Access Compliance Report

Public Rights-of-Way

(Pedestrian Signals)

Intersection ID: N/A	Main Street:	Cross Street: N/A	Location: N/A
ADA ID: AB8DE6AB52B0	Signal Type: Two Push Buttons-Non APS	Overall Compliance: No	Severity Score: BTN 1:N/A BTN 2: N/A No BTN: N/A
Codes/Mitigation Info/Possible Solution		Field Measurements/Component Compliance

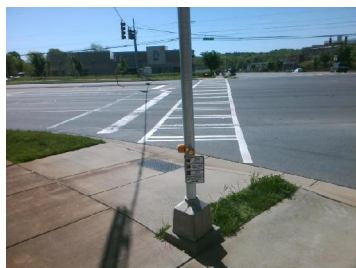
PROW/ADA: TMUTCD 4e.08, R404.2, R404.3, R406.2

Compliance	Description	Data	Compliance	Description	Data
	Button Count	Button2	N/A	Distant to Additional Button (in)	N/A
	Additional Button Present?	N/A		Additional Button ID	N/A
N/A	Signal Buttons Required?	N/A	N/A	Additional Ped Posts Required	N/A
	How Many Ped Street Xings?	2		Located In An Island/Median?	No
N/A	B 1 Sign Present?	Yes	N/A	B 2 Sign Present?	Yes
Yes	B 1 Sign Purpose?	Yes	Yes	B 2 Sign Purpose?	Yes
Yes	B 1 Sign Lettering & Contrast?	Yes	Yes	B 2 Sign Lettering & Contrast?	Yes
Yes	B 1 Parallel To XWalk?	Yes	Yes	B 2 Parallel To XWalk?	Yes
Yes	B 1 PAR to Button?	Yes	Yes	B 2 PAR to Button?	Yes
Yes	B 1 PAR to XWalk?	Yes	Yes	B 2 PAR to XWalk?	Yes
Yes	B 1 Clear Floor Space?	Yes	Yes	B 2 Clear Floor Space?	Yes
N/A	B 1 FWD Approach?	Yes	N/A	B 2 FWD Approach?	Yes
N/A	B 1 FWD Approach Constrained?	No	N/A	B 2 FWD Approach Constrained?	No
No	B 1 FWD Approach Reach (in)	7.0	No	B 2 FWD Approach Reach (in)	10.0

N/A	B 1 FWD Approach Width (in)	N/A	N/A	B 2 FWD Approach Width (in)	N/A
N/A	B 1 FWD Approach Obstruction?	Yes	N/A	B 2 FWD Approach Obstruction?	Yes
N/A	B 1 FWD Approach Obstruction Dist (in)	2.5	N/A	B 2 FWD Approach ObstructionDist (in)	8.0
N/A	B 1 PARA Approach?	Yes	N/A	B 2 PARA Approach?	Yes
N/A	B 1 PARA Approach Constrained?	No	N/A	B 2 PARA Approach Constrained?	No
Yes	B 1 PARA Approach Reach (in)	7.0	Yes	B 2 PARA Approach Reach (in)	6.0
N/A	B 1 PARA Approach Width (in)	N/A	N/A	B 2 PARA Approach Width (in)	N/A
N/A	B 1 PARA Approach Obstruction?	Yes	N/A	B 2 PARA Approach Obstruction?	Yes
N/A	B 1 PARA Approach Obstruction Dist (in)	2.5	N/A	B 2 PARA Approach ObstructionDist (in)	2.0
No	B 1 Clear Floor Space Slope (%)	3.3	No	B 2 Clear Floor Space Slope (%)	2.5
No	B 1 Clear Floor Space XSlope (%)	5.8	No	B 2 Clear Floor Space XSlope (%)	6.6
N/A	B 1 PAR Slope (%)	2.3	N/A	B 2 PAR Slope (%)	1.0
Yes	B 1 Height (in)	41.0	Yes	B 2 Height (in)	41.0

Yes	B 1 Clear Xing Direction?	ClearlyMarked	Yes	B 2 Clear Xing Direction?	ClearlyMarked
	B 1 Crossing Direction	To SW		B 2 Crossing Direction	To SE
Yes	B 1 DistanceTo XWalk (in)	0.0	Yes	B 2 DistanceTo XWalk (in)	0.0
No	B 1 DistanceTo Curb (in)	91.0	No	B 2 DistanceTo Curb (in)	93.0
Yes	B 1 Diameter (in)	2.0	Yes	B 2 Diameter (in)	2.0

Possible Solutions: Replace Signal Push Button With APS Button on New Post. Remove & Relocate Sign.
